Changes for Rev E to Rev F (8/11/78, C. Thacker)

<b>XEROX</b> PARC/CSL	<b>Project</b> D0	<b>Title</b> D0 MISC board Changes	<b>File</b> DOMISCChanges.sil	<b>Designer</b> Thacker	<b>Rev</b> Gc	<b>Date</b> 7/17/80
--------------------------	----------------------	---------------------------------------	----------------------------------	----------------------------	------------------	------------------------

SPLAT at b1

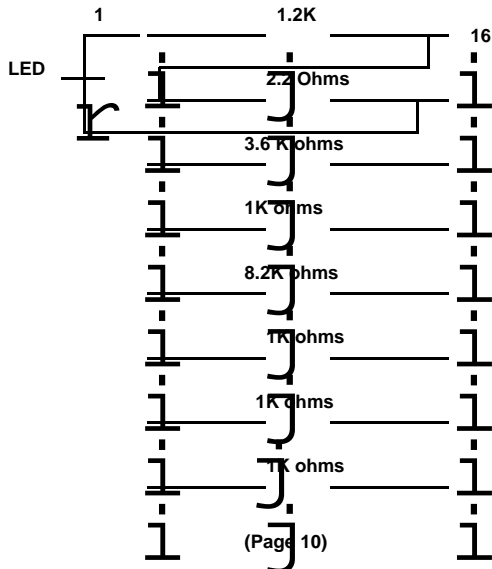
- 1) Changed layout - g1 is S241, not 75188
- 2) Modified platforms b1, a3.
- 3) (pg 1) b17.1 is GND, not PDTf.
- 4) (pg 10) b1.9 is VCC, not GND
- 5) (pg 10) Added S241 driver for PD.0-PD.7. (note - early etch boards will NOT have this change)
- 6) (pg 12) i6.14 is PDTe, not LoadAdd
- 7) (pg 13) i4.1 is PDTf, not GND
